ADDENDUM NO. 3

DATE: July 14, 2016
FROM: City of Grand Junction Purchasing Division
TO: All Offerors
RE: RFP-4267-16-DH New Data Center Server Cabinets and Cold Aisle Containment for New City Hall I.T. Server Room Project

**GRAND JUNCTION, CITY HALL
 SERVER ROOM**
 250 N. 5TH STREET
 GRAND JUNCTION, COLORADO

ELECTRICAL FLOOR PLAN

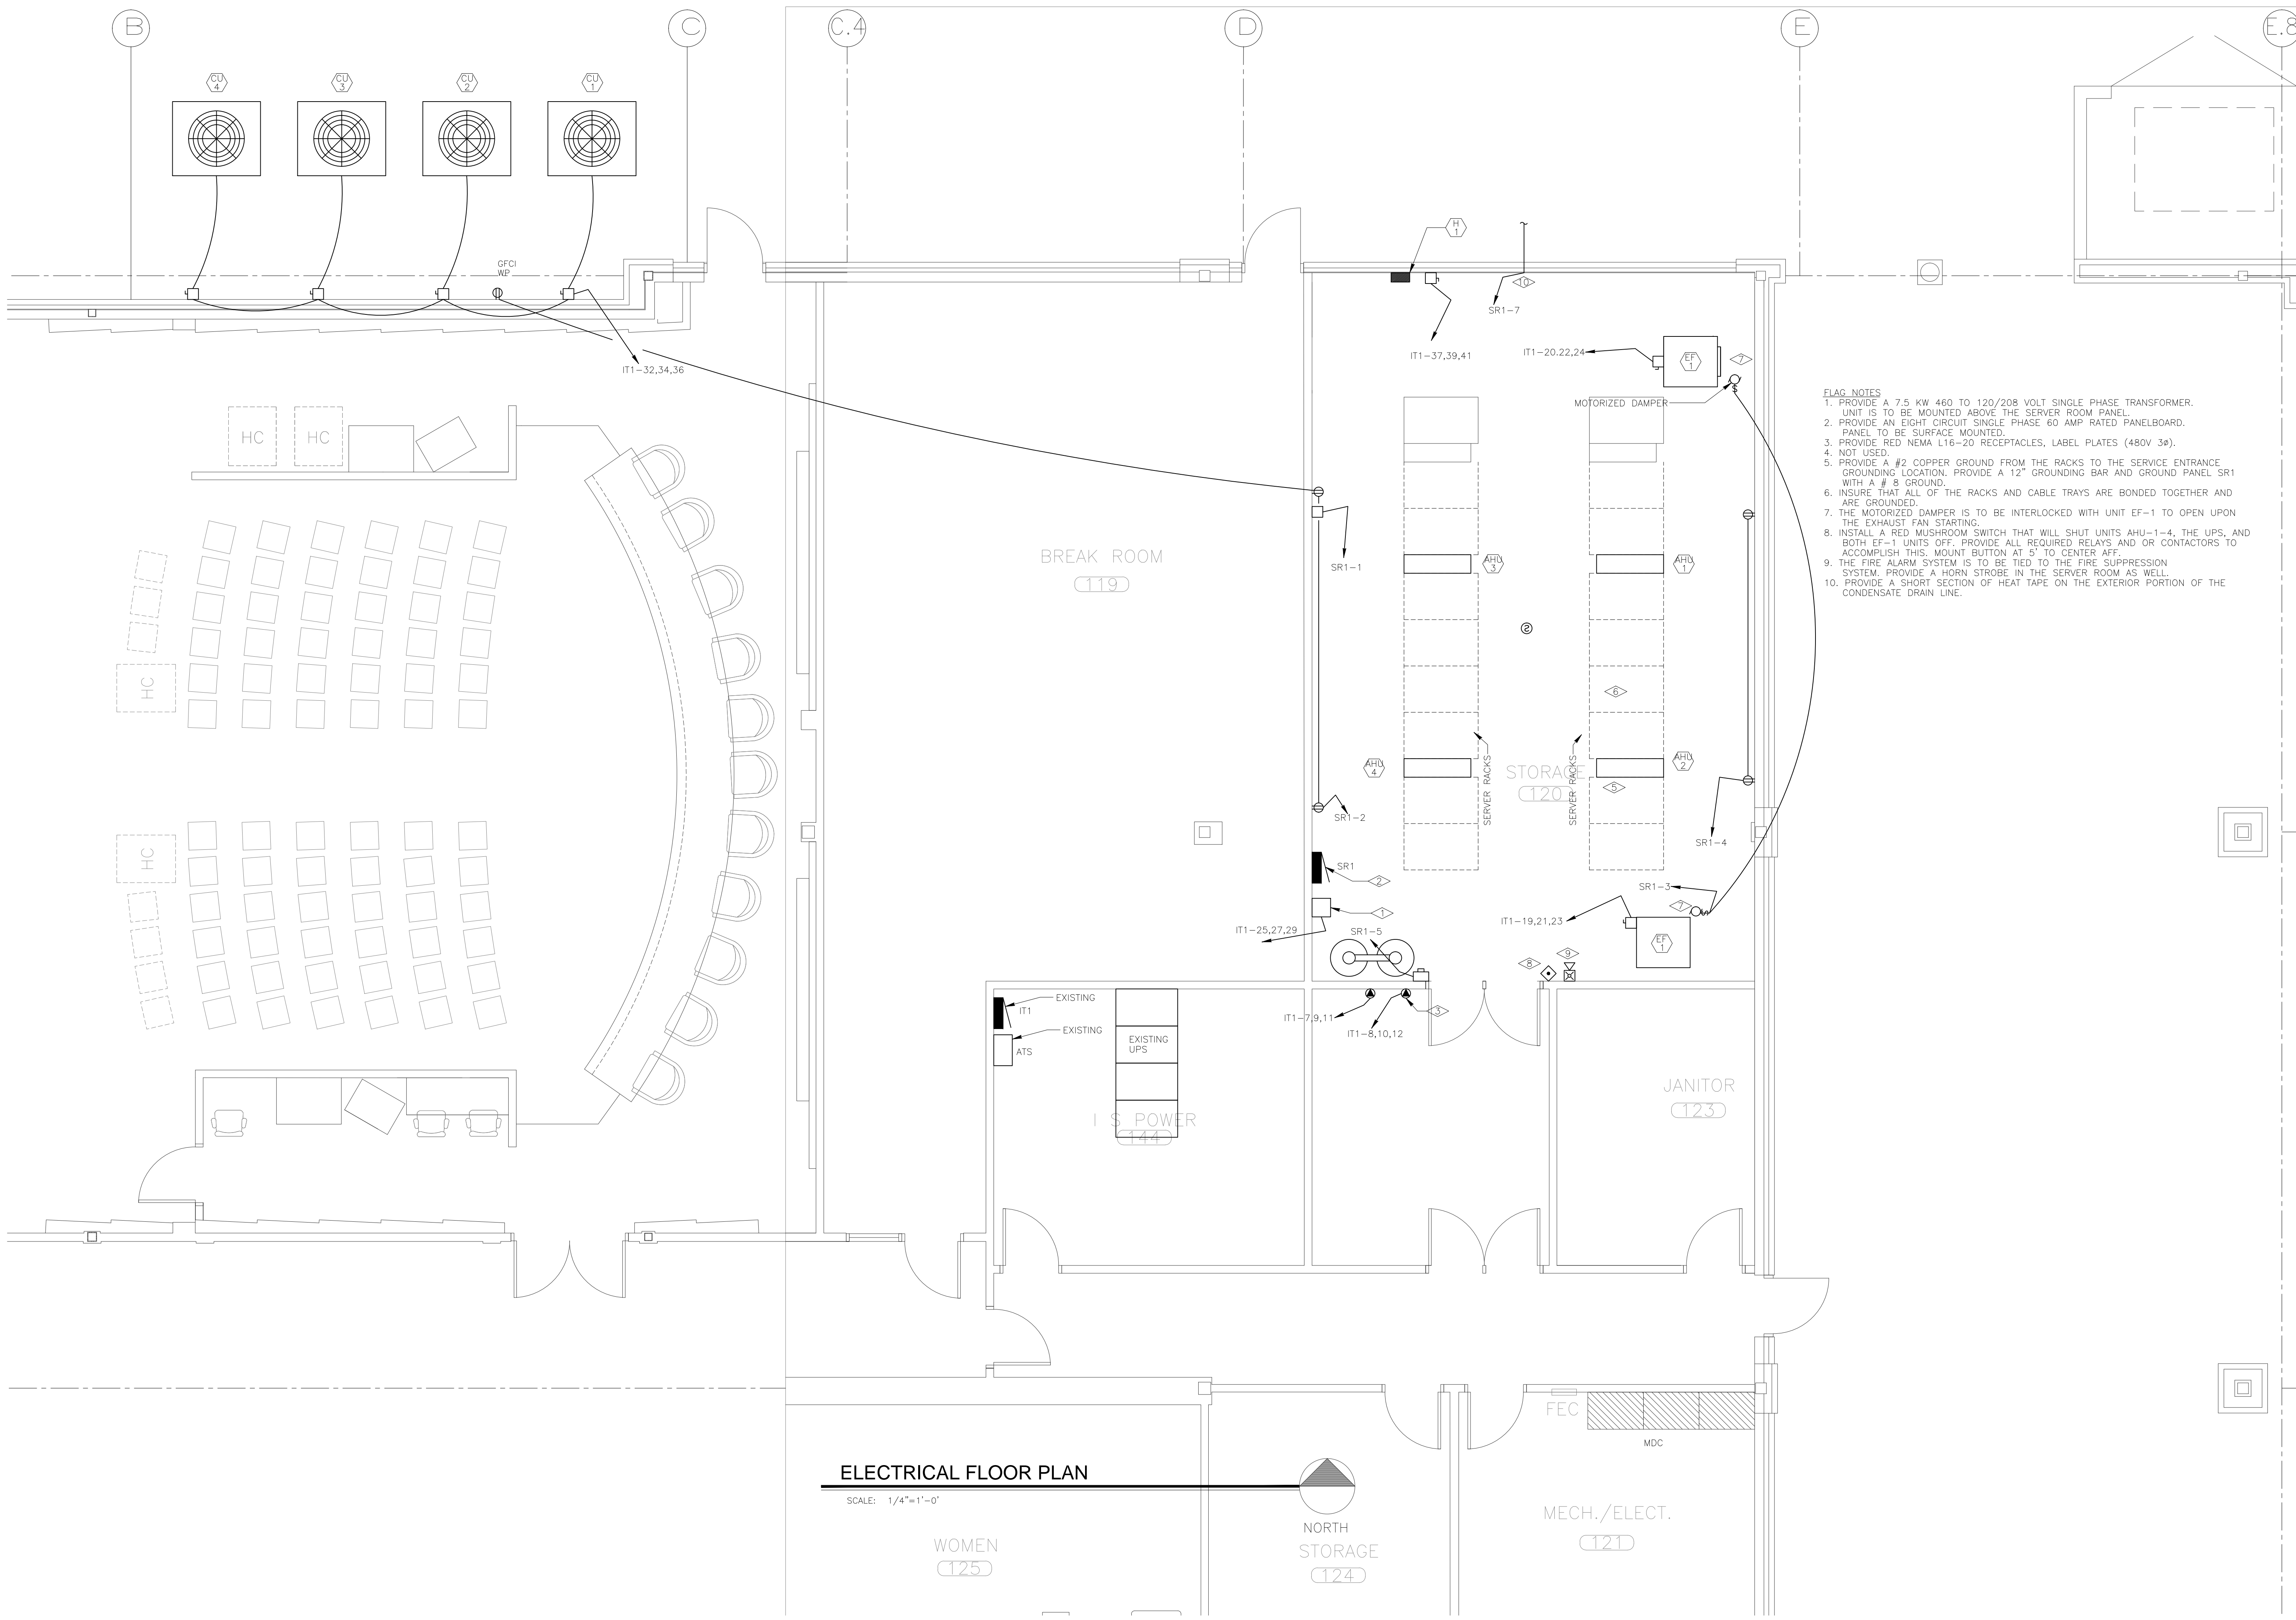
11. Q. Can the doors be constructed as solid doors with windows?
- A. Yes, as long as we can see into the aisle.
12. Q. Are strictly looking at solutions with horizontal containment or is vertical containment an option?

- A. When submitting your proposal, please explain the difference in these options.
13. Q. Will a supplemental drawing be supplied to include the width of the aisle?

- A. Yes, see attached.
14. Q. Can we supply options for alternative doors?
- A. Yes, see answer 5-A above.
15. Two firms attempted to dial-in to our conference call line, but due to circumstances beyond their control (the conference line became full and at that point didn't allow additional callers into the conference call) were not able to get through. Therefore, two additional firms shall be added to the mandatory sign in sheet as in attendance. This updated sign in sheet has been posted to the City's website, www.gjcity.org and click on Bids, and also to the Rocky Mountain E-Purchasing System.
